SUBMISSION

SCOTT & JAYE CHADWICK, 91 MARINE PARADE AVALON

RE: DA 2023 1780
89 MARINE PARADE AVALON
WRITTEN SUBMISSION: LETTER OF OBJECTION
SUBMISSION: TULLOCH

15. IMPACTS UPON ADJOINING PROPERTIES: PRIVACY

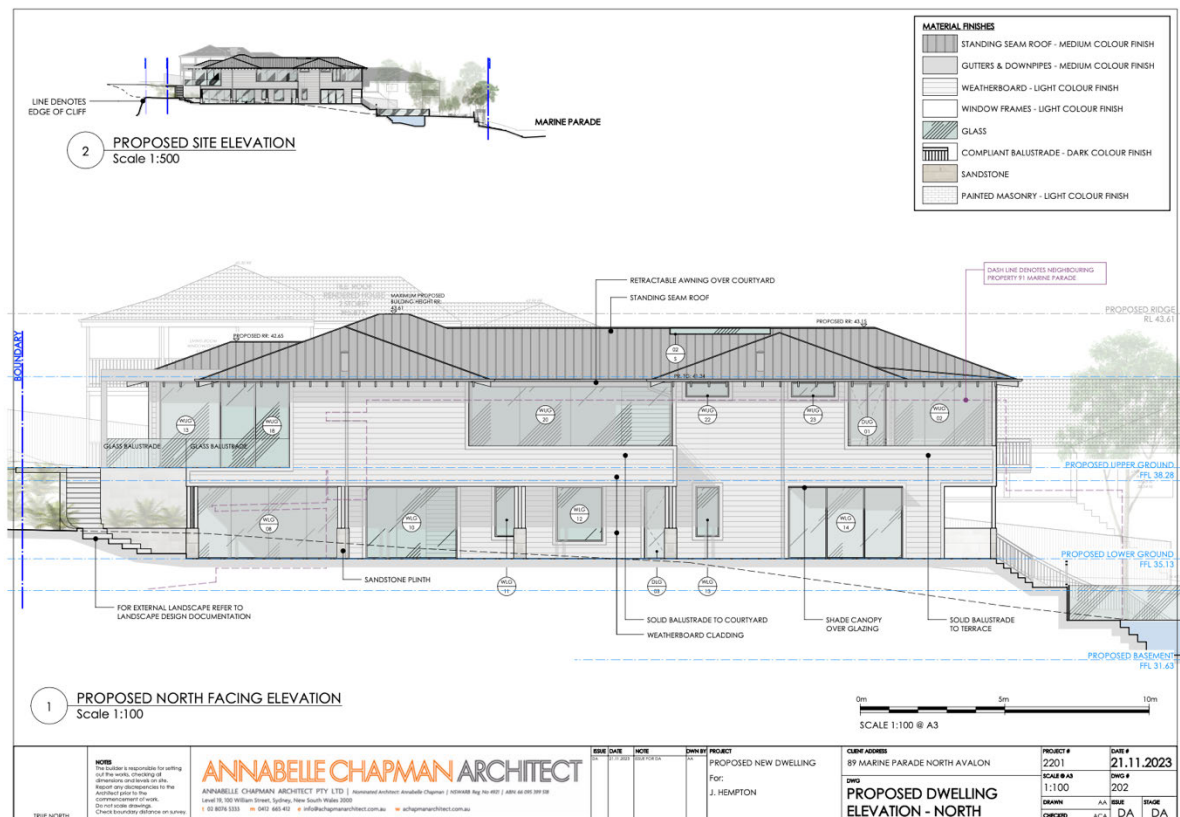
The proposal is contrary to Section 4.15(1)(a)(iii) of the *Environmental Planning and Assessment Act 1979* as it will have unacceptable impacts upon the amenity of neighbours' property, specifically with regard to visual privacy.

The proposed development should be refused as it will have unacceptable impacts upon the amenity of my clients' property, specifically with regard to visual privacy.

Response: The proposed development results in a privacy impact with the proposed windows facing neighbours without sufficient screening devices being provided, considering the proposed windows are directly opposite my clients' windows and balconies.

Response: The windows in question are windows of the main circulation zones and living areas, it is considered that the living areas will result in an unacceptable privacy breach. The proposed windows and decks face the rear private open spaces for the neighbouring dwelling and will result in an unacceptable level of privacy impact.

Comment: As the development is considered to result in an unacceptable privacy impact due to the design, it is requested that the proposed development be redesigned to reduce amenity impact on the neighbouring properties.

- All windows facing my client's property to have windows sills increased to a minimum height of 1.5m measured from the FFL level, or All windows facing my client's property to have frosted/translucent glazing up to a minimum height of 1.5m above the FFL.
- 1.7m high louvred privacy screens added to the edge of all elated balconies, decks, and courtyards facing my clients' property. 1.7m high louvred privacy screens added to the edge of the proposed pool facing my clients' property. Louvred privacy screens shall be fixed and angled at a 20-degree acute angle to the angle of the proposed development.
- All privacy screens are to have fixed louvre blades with a maximum spacing of 25mm, and shall be constructed of materials and colours that complement the finishes and character of the building.
